**APPLICATION BY NATIONAL GRID ELECTRICITY TRANSMISSION PLC FOR A
DEVELOPMENT CONSENT ORDER PURSUANT TO SECTION 37 PLANNING ACT 2008 FOR
THE NORWICH TO TILBURY ELECTRIC LINE ABOVE GROUND**

PLANNING INSPECTORATE REFERENCE: EN020027

**DEADLINE 3: RESPONSE TO EXQ1 - SUBMISSION OF “ARU WRITTLE” (BEING THE
COLLECTIVE TRADING NAME AND TRADEMARK FOR THE ENTITIES: ANGLIA RUSKIN
UNIVERSITY AND WRITTLE COLLEGE LIMITED)**

Subject National Grid Access through ARU

Figure 2.1 – Insert from Section F Sheet 8 of 10

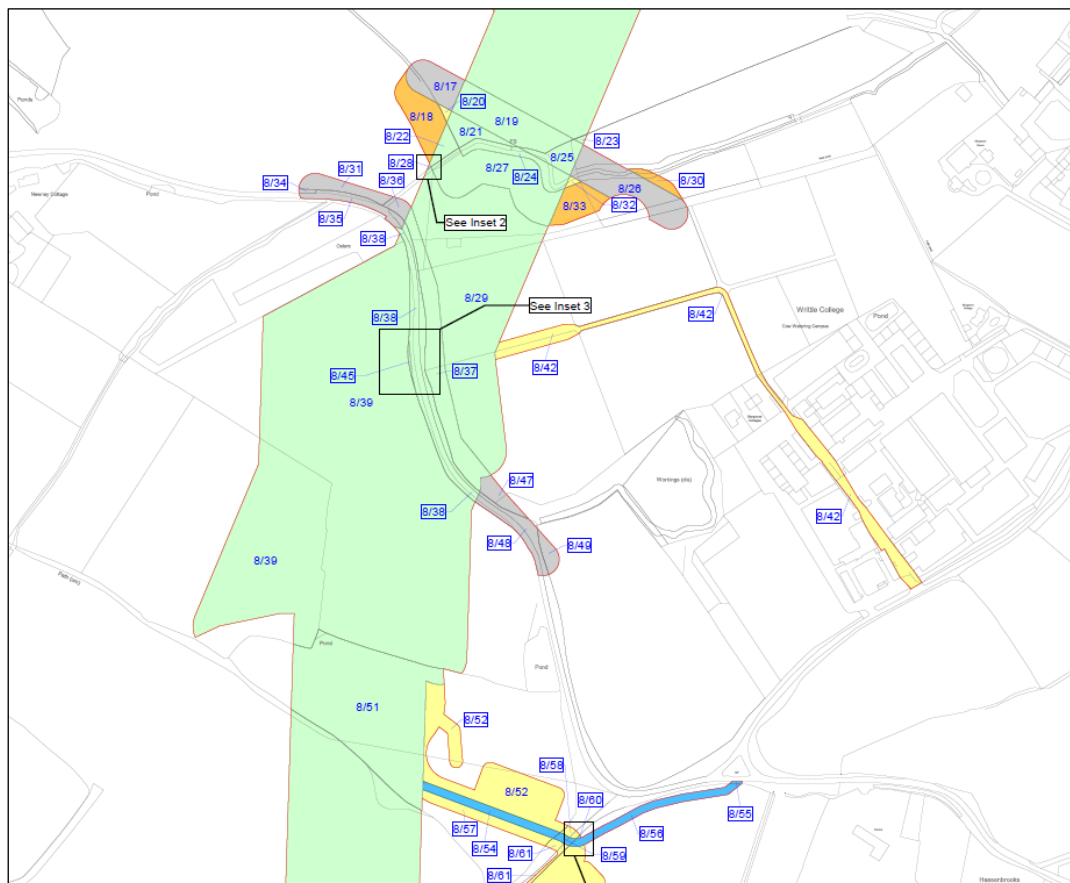
2.2.1 Section F Sheet 8 of 10 of *Response to Section 51 advice - Accepted at the Discretion of the Examining Authority - 2.2 Land Plans - Section F - Revision B [AS-010]* identifies the permanent access route as Plot 8/42, desired by the Applicant to traverse perpetually through the ARU site, shown in yellow in **Figure 2.1** below. **Figure 2.1** shows this route and also the close-by highway that traverses the green land inside of the DCO application area for the pylon and overhead cables. It can be seen that the existing highway is actually inside the green area and closer to the pylons and overhead cables between them. A site inspection shows there to be no physical impediment to traversing from the highway to the green coloured area.

2.2.2 F-8/42 is referred to in the Development Consent Order (DCO) at Schedule 11 'Land of which Temporary Possession may be Taken' and is not expressly conditioned to be time limited to the

- 2.3.9 Therefore, it is not possible for the ExA to consider, nor for the Secretary of State to determine and weigh the type of access arrangements that are desired by NGET for the access to Work No.17 at this location nor the full extent of the level of impact it would have on the ARU Writtle site's operation, nor whether or not the access route identified by NGET in **Figure 2.1** is required at all.

2.4.2 Paragraph 1.6.1 identifies that the purpose of the CTMP is to manage construction traffic impacts on the local road network. This is confirmed at paragraph 1.7.2, which states the CTMP ‘only applies to the construction phase of the Project, not including operation, maintenance or decommissioning. Therefore, no evidence has been provided at this time on the operation, maintenance or decommissioning phases of the project works, and the related impacts on the ARU land, in particular in relation to the actual use of the yellow coloured route identified on **Figure 2.1** above.

Figure 2.2 – Transport Assessment Traffic and Transport Study Area (Page 26 of 30)

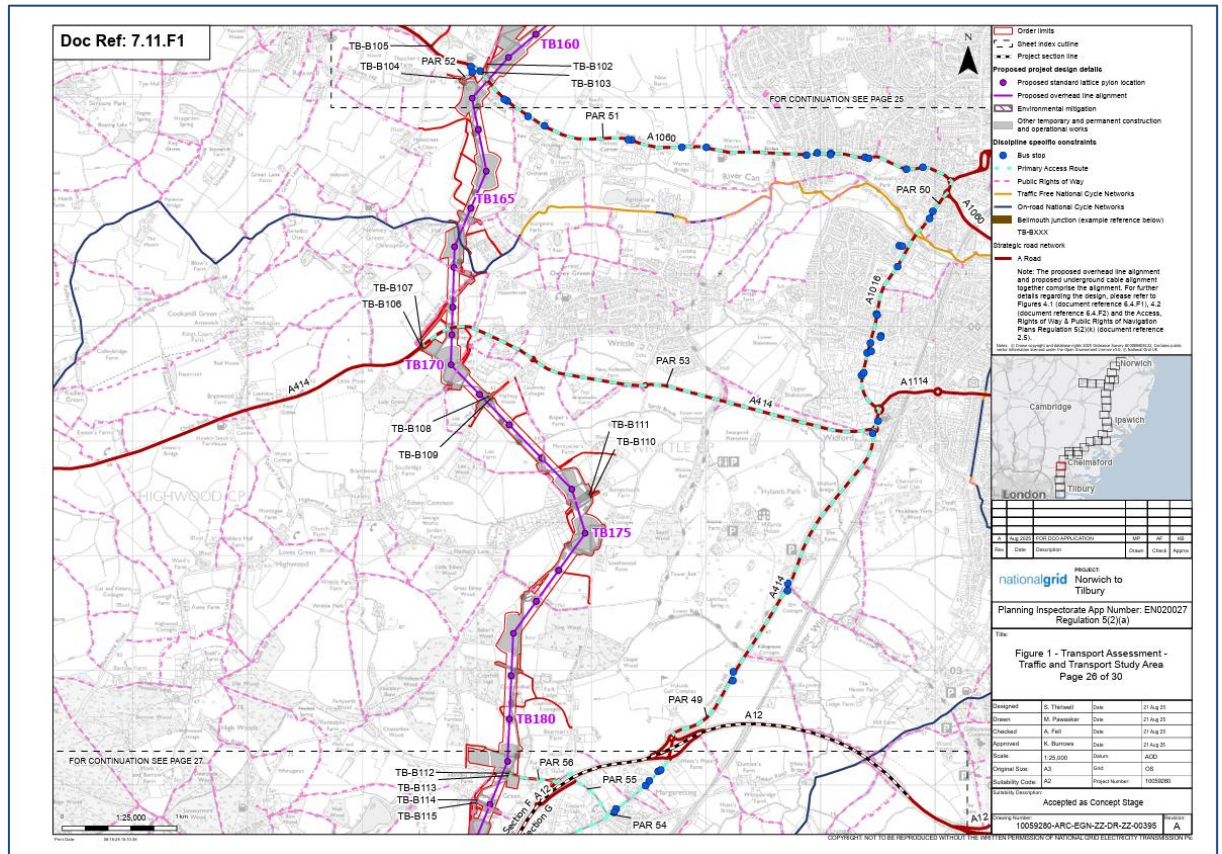
- 2.3.11 Sheet 26 of Transport Assessment – Appendix I – Figures [APP-342] is provided below and shows the PAR running to TB-B106 and TB-107, and on the basis of Section 6.8 it is understood that the Applicant hopes that all construction traffic would enter the construction site via this route. I note, however, that no construction or development contract has been let and there appears to me no express term in the draft SI or other document that ensures the hopes of the Applicant will be carried out.

2.3.12 Both the Environmental Statement and Transport Assessment envisage that construction traffic will access the works via the PAR. On this basis with regards to the construction of the project, it is not understood what the purpose of the access is nor the scale of its use. This should be clarified. As noted above, no construction or development contract has been let and there appears to me no express term in the draft SI or other document that ensures the Applicant’s desired strategy will be carried out in the desired way set out in the ES and the TA.

Figure 3.1 – Internal one-way route

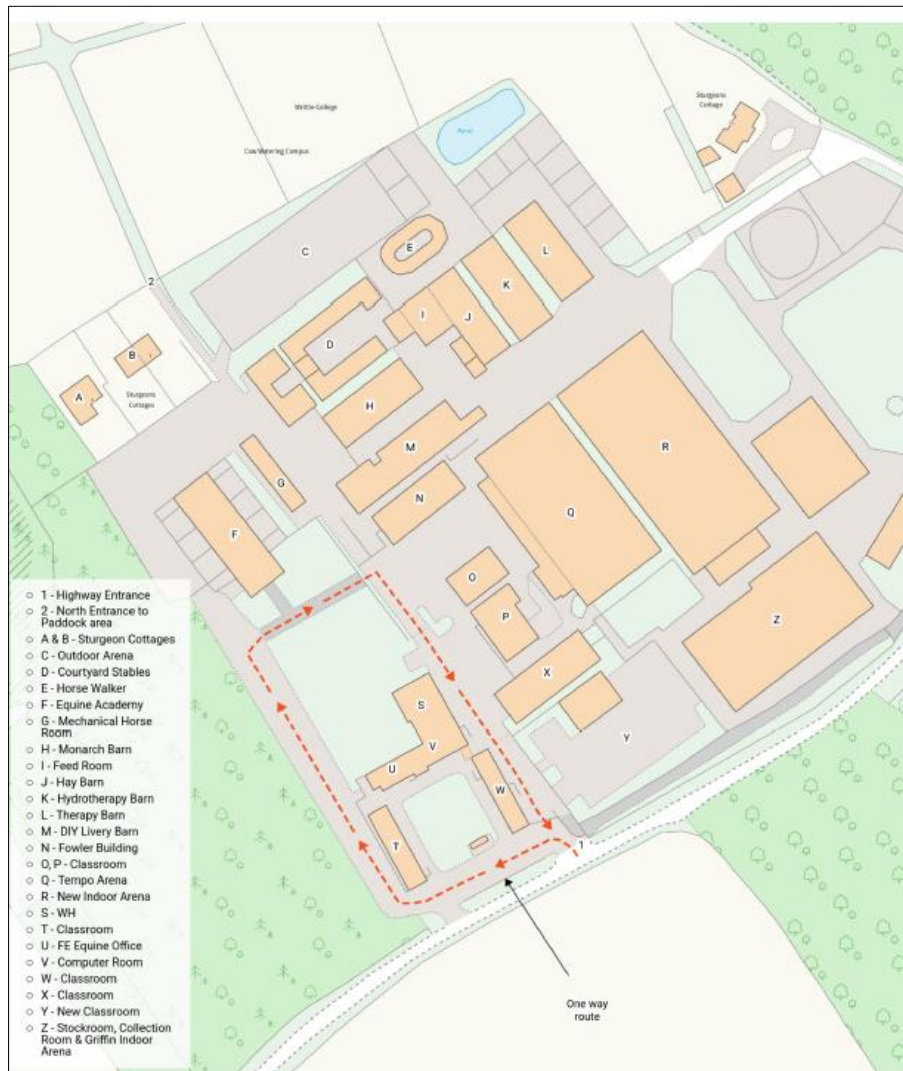
- 3.3.3 Once vehicles have entered the site, they utilise an internal one-way system (shown at Figure 3-1 below) to minimise internal conflict. The Applicant's red line area and the related yellow coloured area of Plot 8/47 would result in its desire for its vehicles to utilise the site's vehicle exit junction as an entry route and then move through the site in opposition to the currently utilised one-way system. This desired approach would result in conflicts with high sensitive receptors and an increased risk of collision.

- 3.3.4 This internal road of the site is the main access for student and staff accessing the facility, and runs directly alongside teaching classrooms. It is utilised constantly throughout the day by students and horses moving around the site.

3.3.5 The ARU Writtle Campus is organised, and intentionally functions as a horse-friendly and pedestrian-dominated environment, with education activities. Existing vehicle speeds are very low, use of heavy vehicles is very rare, and the few drivers using internal roads in the facility are accustomed to seeing horses and pedestrians regularly and to accommodating horses and pedestrians at very close quarters. All users of the site must utilise the internal one-way system.

Figure 4.1 – Alternative Access Routes

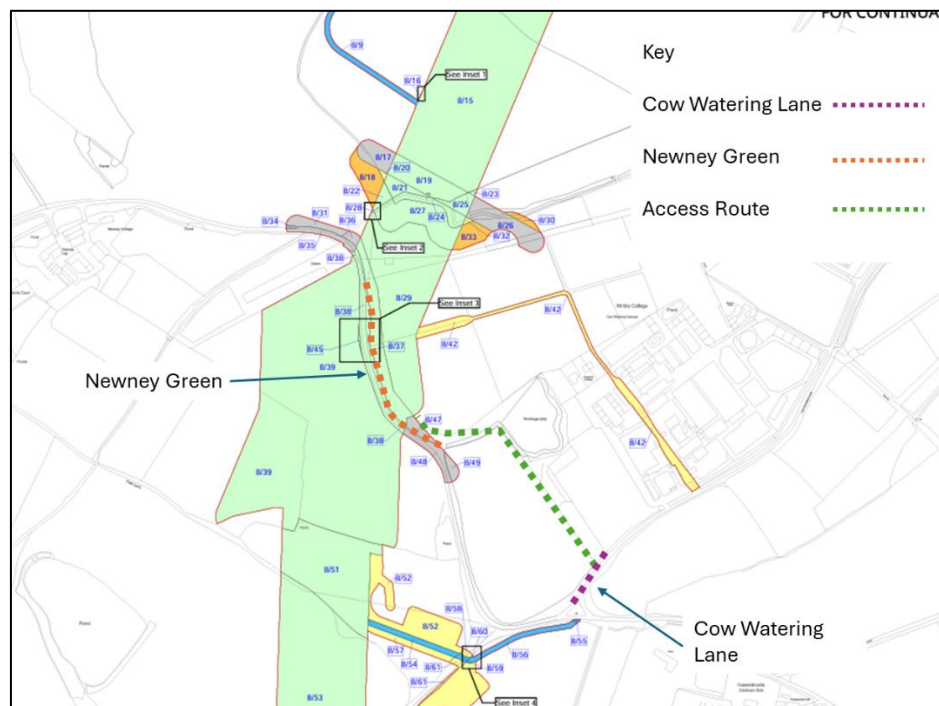
4.1.2 Two alternative access arrangements have been considered at a high level by ARU (shown in Figure 4.1) and are recommended to be actually assessed and considered by the Applicant:

- Cow Watering Lane (to the west) (represented indicatively by purple dashed line)
- Newney Green (represented indicatively by orange dashed line)

4.1.3 Both accesses would require a priority junction arrangement but one is situated inside the area of the DCO outlined in red and coloured green and a requirement could ensure the other. The scale of the junction would be determined by the frequency and type of vehicle movement (e.g. will HGVs require access), which is unknown, along with discussions with the highway authority on their requirements.

- 1) The Applicant should assess the deliverability of suitable alternative access from either alternative access locations prior to Deadline 5 of the DCO examination, or as soon as possible, and provide these to the highway authority and ARU Writtle for comment. The locations for the alternative access would be required to be included in express terms in the draft DCO SI Schedule 9 so that they can be implemented under Article 17 part 1(a).

- 2) The highway authority and ARU Writtle to comment on the suitability of the alternative access by Deadline 6, so the Examining Authority can make an informed decision on the practicality of the alternative accesses as well as their relative benefits and disbenefits.
